SR 3/US 41/Northside Parkway/ Cobb Parkway

**Project Number: BHFST-0001-05 (024), P.I. No.: 720125
and CSSTP-0009-00 (410), P.I. No.: 0009410
Fulton/Cobb Counties**

Value Engineering Study Report

August 2009

WALL NO. 4

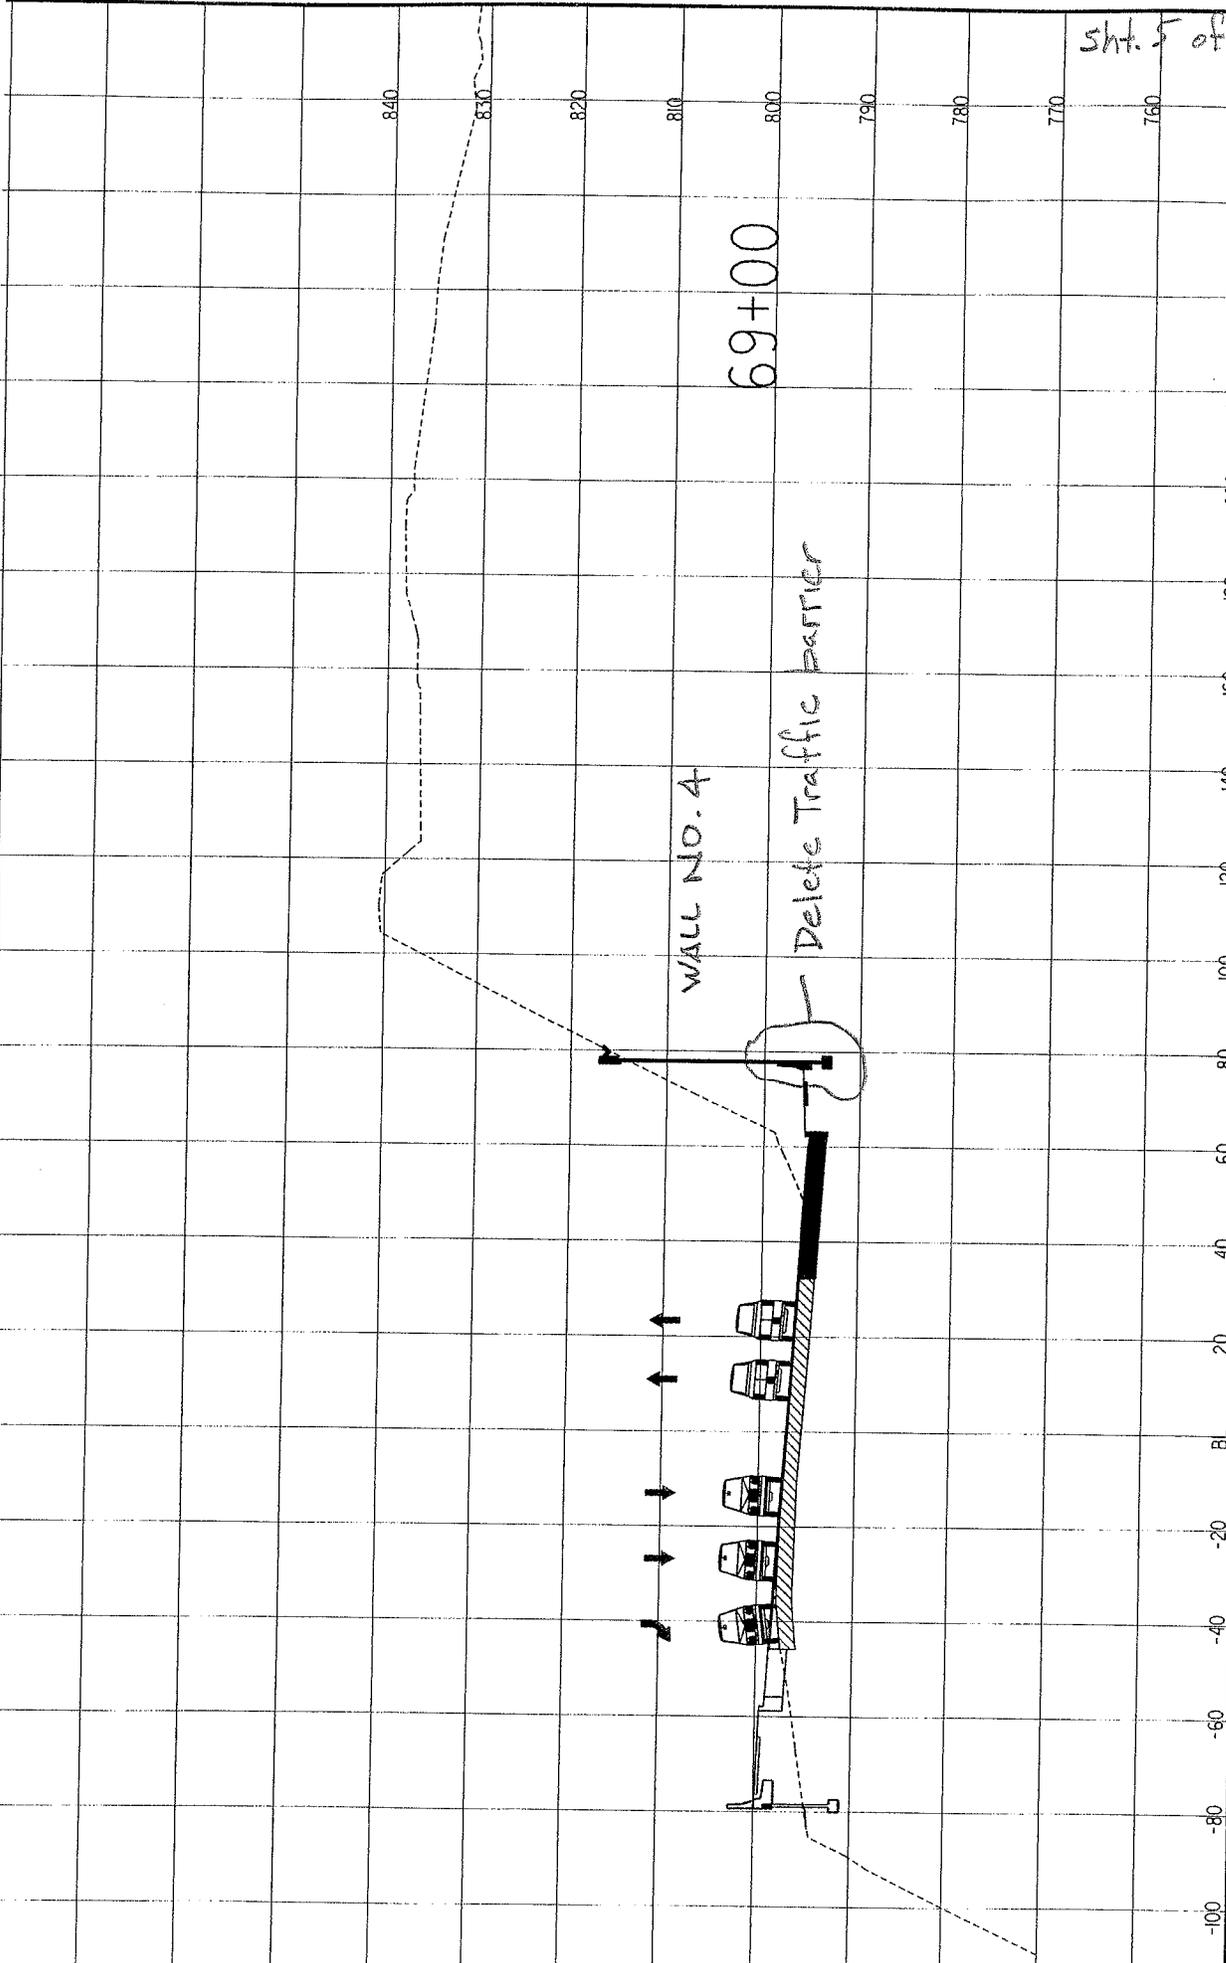
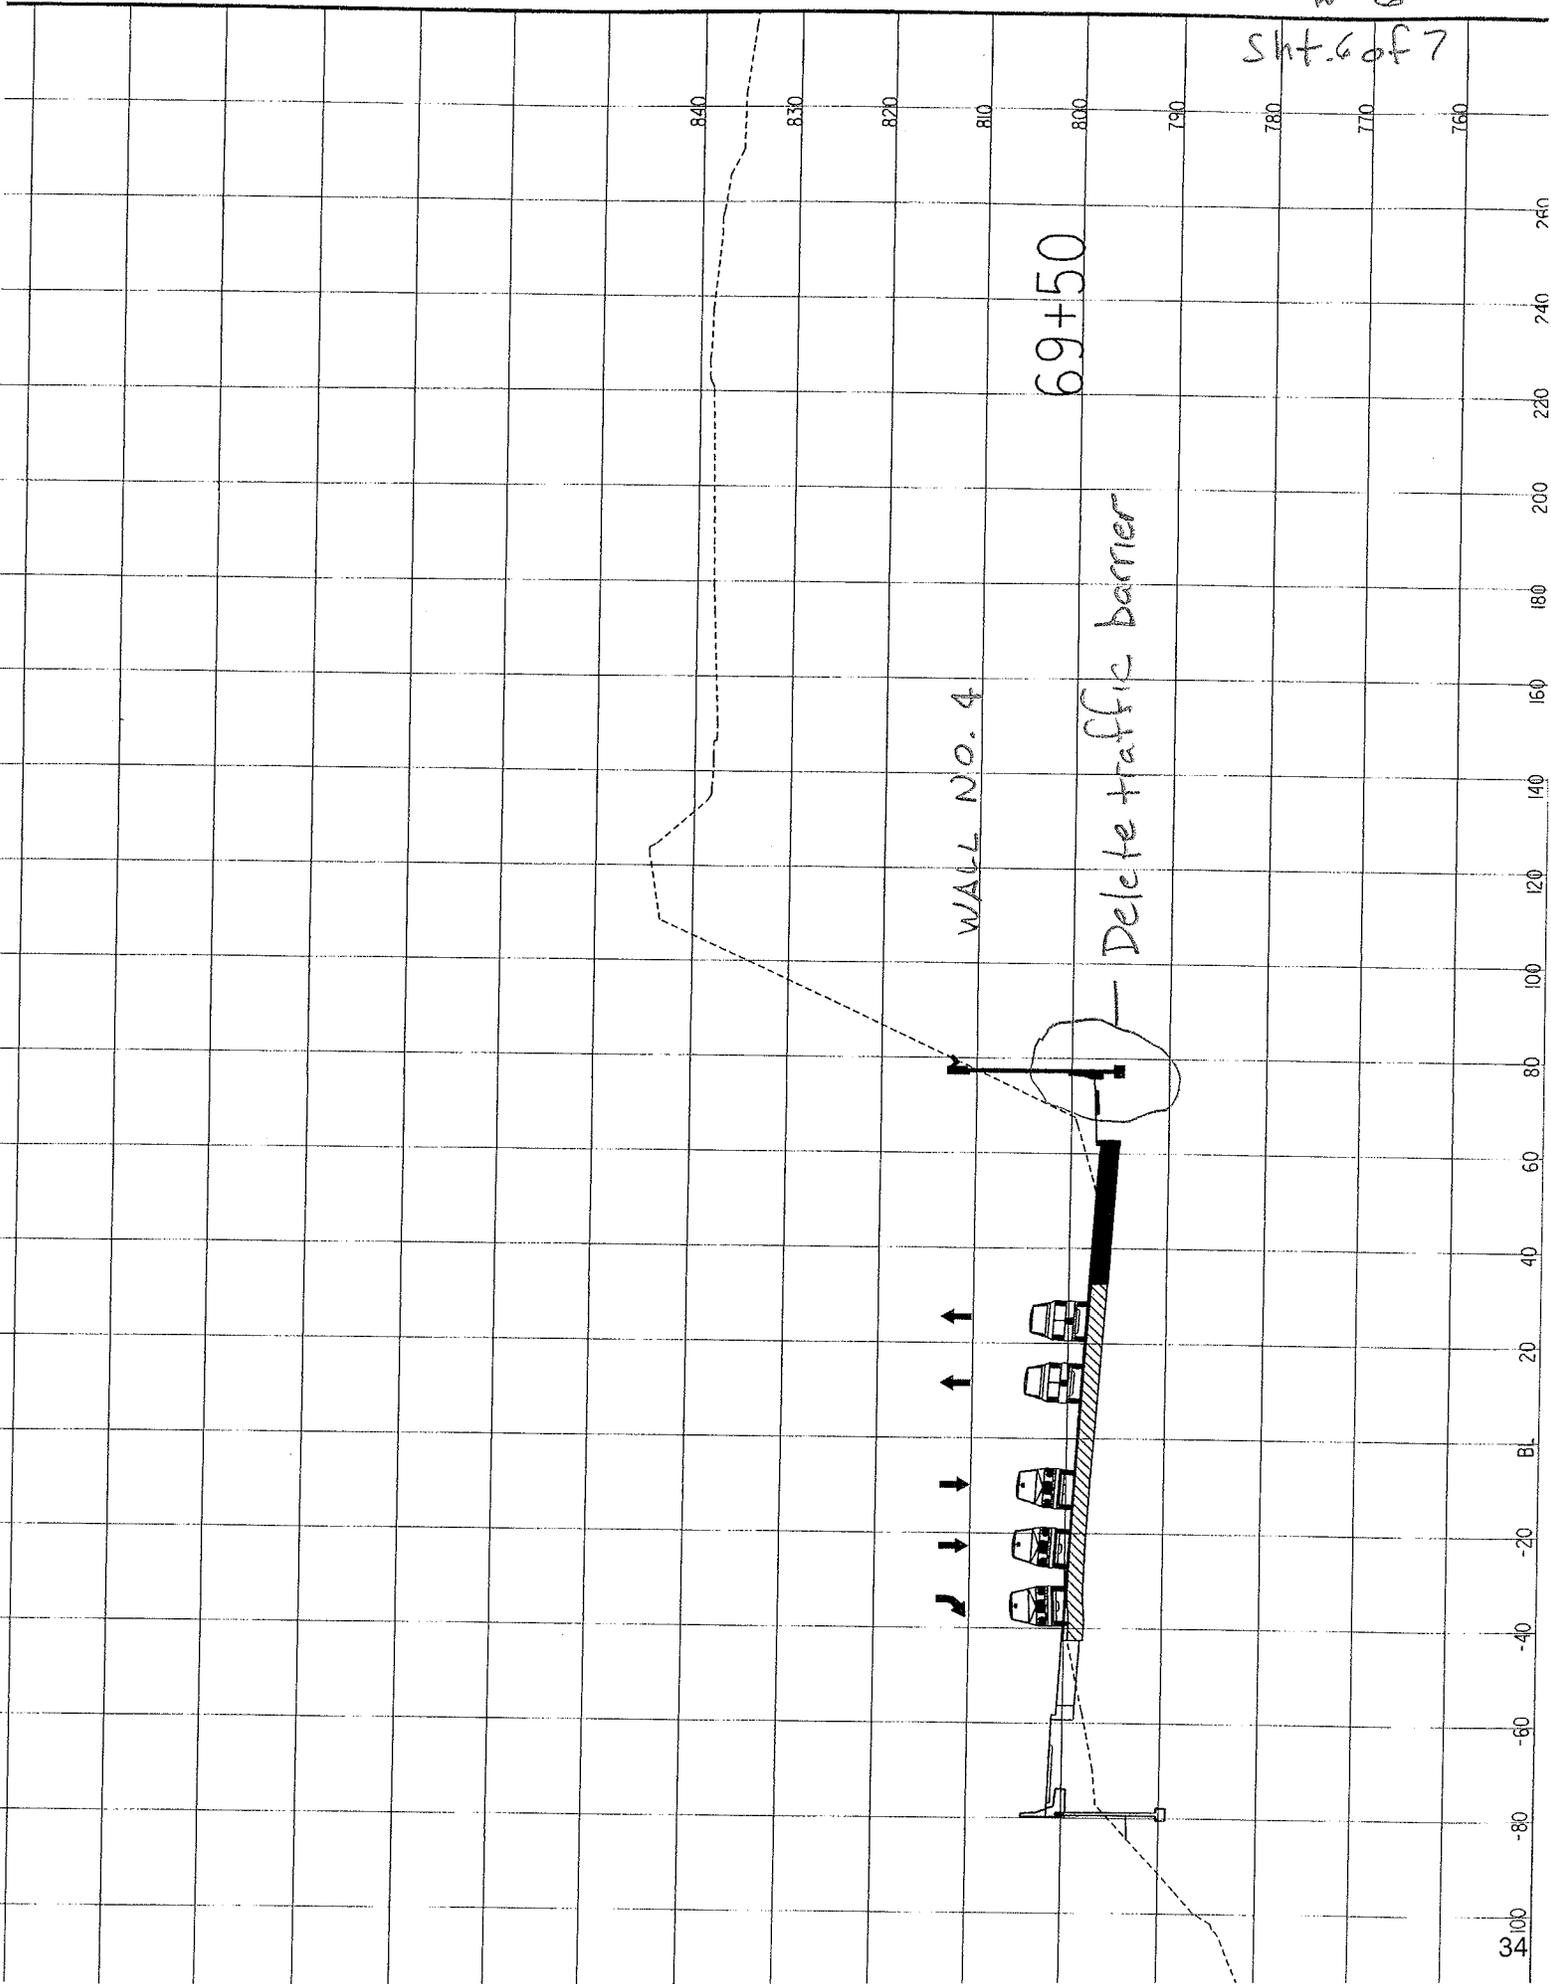
Delete these barriers.

These barriers are being installed to protect a mechanically stabilized embankment wall that is set back from the road about 16 ft. There is a curb at the edge of the roadway and a 16 ft clear zone that will keep most vehicles from getting to the wall. The extra wall protection adds to the project's cost while providing little functionality.

Delete traffic barrier

Delete traffic barrier

Delete traffic barrier

DESCRIPTION: **IN PHASE I, USE A BIN-TYPE WALL FOR THE MECHANICALLY STABILIZED EMBANKMENT WALL NO. 2** SHEET NO.: **1 of 4**

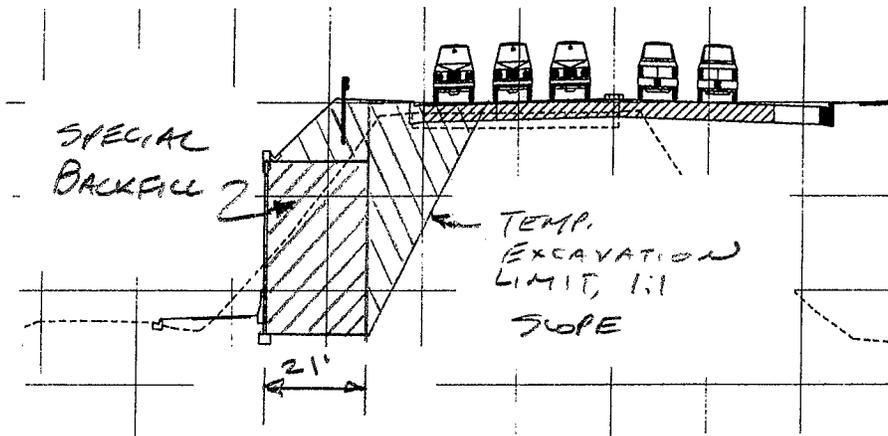
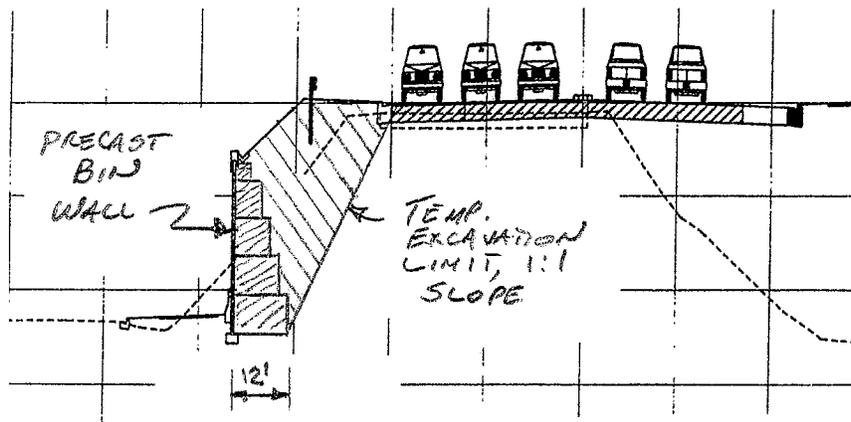
This wall is between the mainline and Chattahoochee NRA Drive West. As such, material will have to be excavated to construct the wall, and some existing pavement will also have to be removed. The soil reinforcements for an MSE wall will be approximately 20 ft long at the highest point of the wall. A bin wall for that height would have a bottom unit with a base width of about 12 ft. This will result in considerably less excavation and pavement removal to construct this wall. Although bin walls were fairly common in Georgia in the past, they are not as common now in transportation projects, so obtaining the units may be problematic.
